Flight Procedures Cover Page	Task Action: FLIGHT CHECK	Task Type: IAP	Estimated Chart Date: 03/19/2026	APWS Task ID: 195E6D1244B5406E9E61172D2137BD1F	APWS Project ID: 00C896C3A8AF44F6BC889E6278105E1A
Procedure: ILS OR LOC RWY 17L AMDT 5		Enroute: NO	Specialist: Hirst, Charles		Agreement Number:
Airport ID: KDEN			Airport City: DENVER		State: CO
Facility ID: BXP	Facility Type: ILS	Flight Inspection Remark Type: New FC Slot

Procedure Comments:
REDESIGN MISSED APPROACH. REMOVE ALL REFERENCES TO DEN VOR IN PREPARATION FOR DEN VOR DECOM. AFS REQUIRED.

Denver, CO
Denver International, KDEN
ILS OR LOC RWY 17L

AUTOMATED AL-9077 ILS or LOC RWY 17L

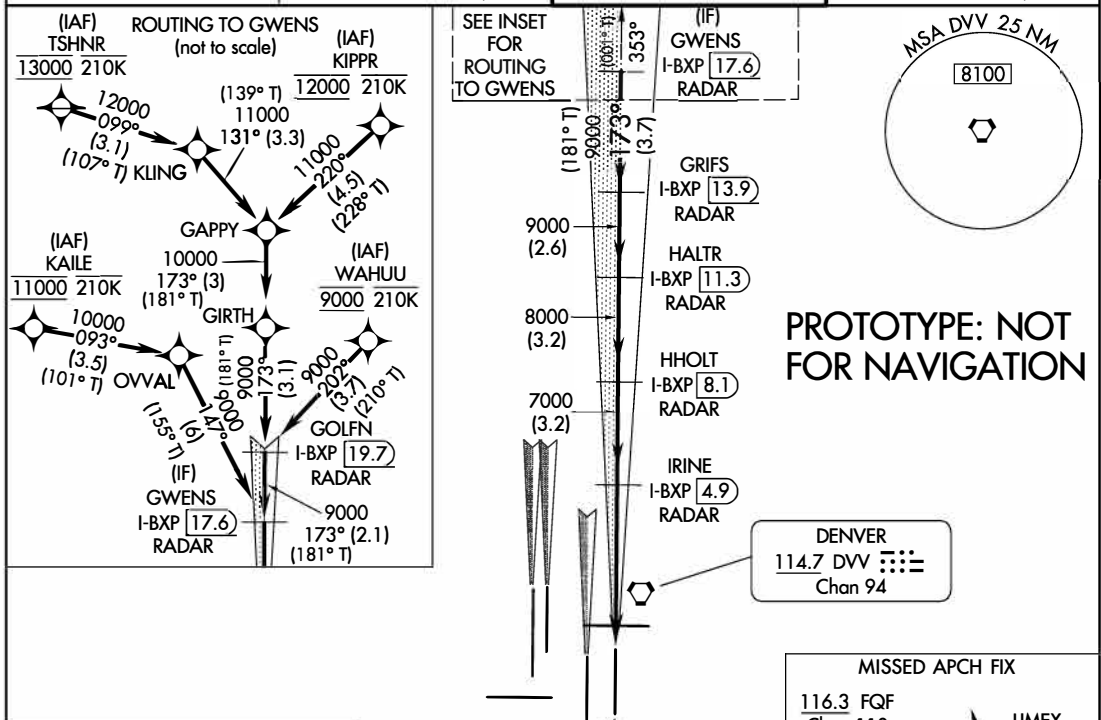
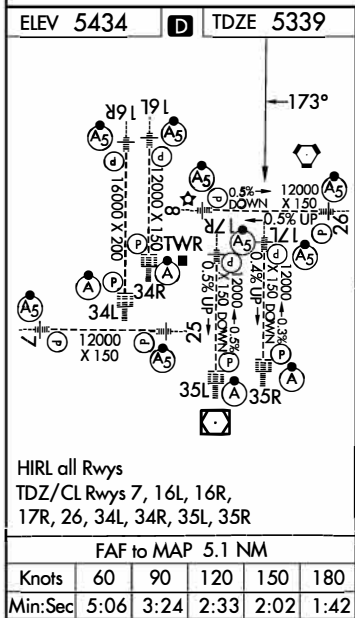
8260-3:
1. ADDITIONAL FLIGHT DATA REMOVED "CHART LOC RWY 17R" - NO LONGER REQUIRED
2. ADDITIONAL FLIGHT DATA REMOVED "CHART LOC RWY 16L" - NO LONGER REQUIRED
3. ADDITIONAL FLIGHT DATA REMOVED "CHART LOC RWY 16R" - NOLONGER REQUIRED
4. ADDITIONAL FLIGHT DATA ADDED "CHART IN PROFILE VIEW: I-BXP DME ANTENNA" - IAW 8260.19K 8-6-11S DME ANTENNA IS BEFORE THE THRESHOLD

MISSED APPROACH: Climb to 5900 then climbing left turn to 10000 on heading 121° and FQF VORTAC R-078 to LIMEX INT/FQF 31.9 DME and hold.
